February 2, 2009
NND-09-0017

Subject: Virgil C. Summer Nuclear Station (VCSNS) Units 2 and 3 Combined License Application (COLA) - Docket Numbers 52-027 and 52-028 Response to NRC Request for Additional Information (RAI) Letter No. 012

SRP Section: 17.5 – Quality Assurance Program Description

Figure II.1-1 SCE&G Organization

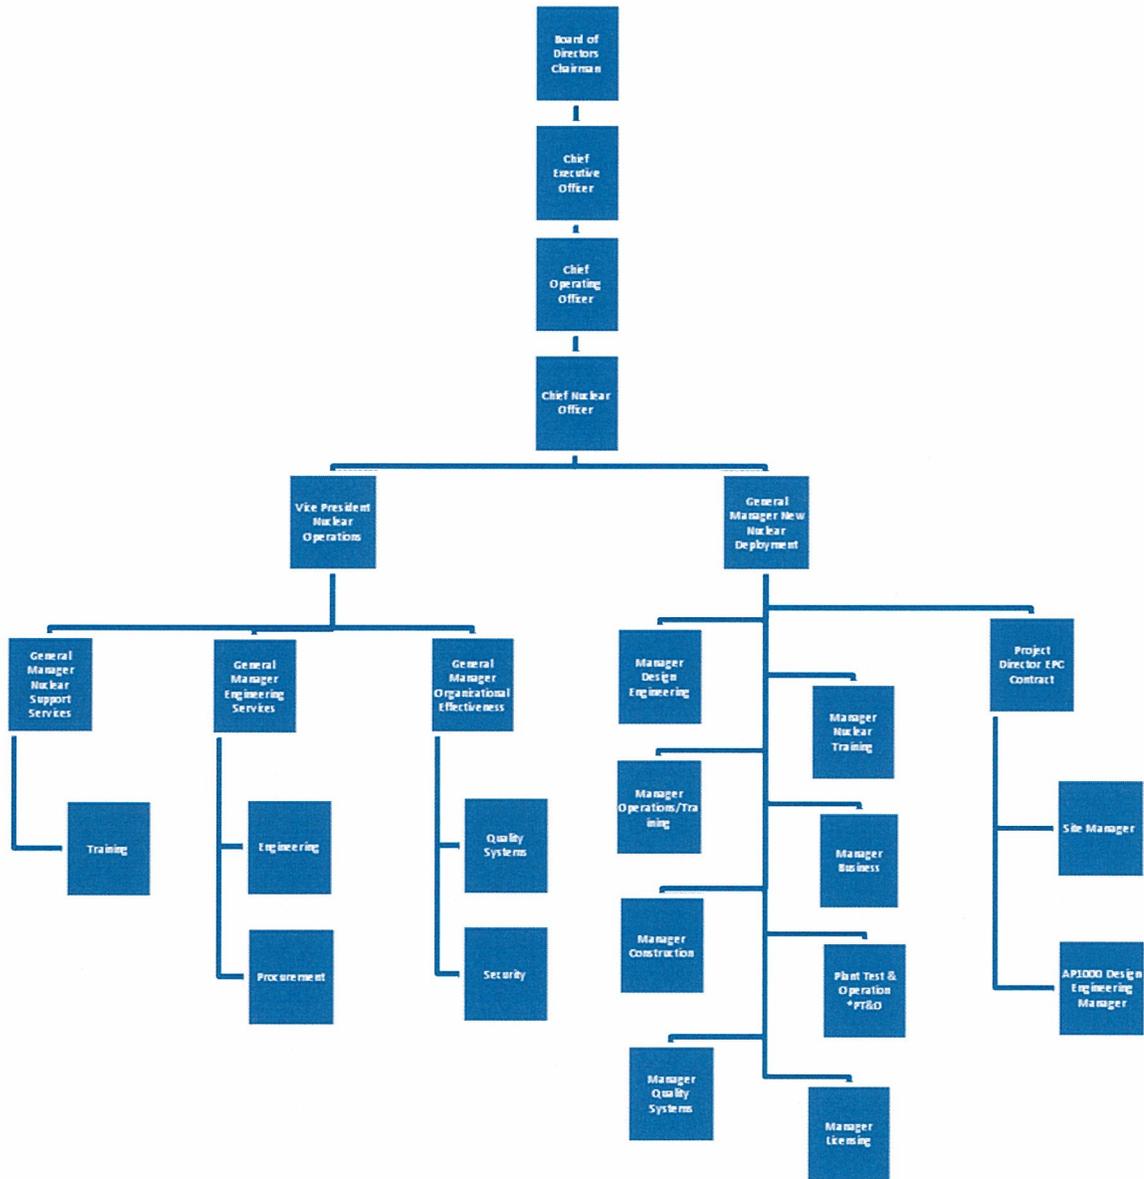
Part II, QAPD Details, Section 1 Organization states, in part, that SCE&G's New Nuclear Deployment (NND) organization is described in the QAPD. Appendix B to 10 CFR Part 50 states, in part, that every applicant for a combined license under 10 CFR part 52 is required by the provisions of section 10 CFR 52.79 to include in its FSAR, a description of the quality assurance applied to the design, and to be applied to the fabrication, construction, and testing of SSCs of the facility and to the managerial and administrative controls to be used to assure safe operation. Please provide the QAPD's description of the managerial organization for operations, including the functions of the following positions that are referred to in Section I, Section 2.6, and Section 2.7: President & Chief Operating Officer (SCE&G), NND Business and Financial Manager, Accounting Manager, Operational Quality Assurance Manager, Site Vice President, and Plant Manager. For additional guidance, please refer to TVA letter dated June 26, 2008 (BLN RAI ID: 341).

The following sections describe the reporting relationships, functional responsibilities and authorities for organizations implementing and supporting the NND QA Program. The SCE&G organization and the NND organization are shown in Figures II. 1-1 and II. 1-2, respectively.

2. Replace Figure II.1-1 in its entirety with the following:
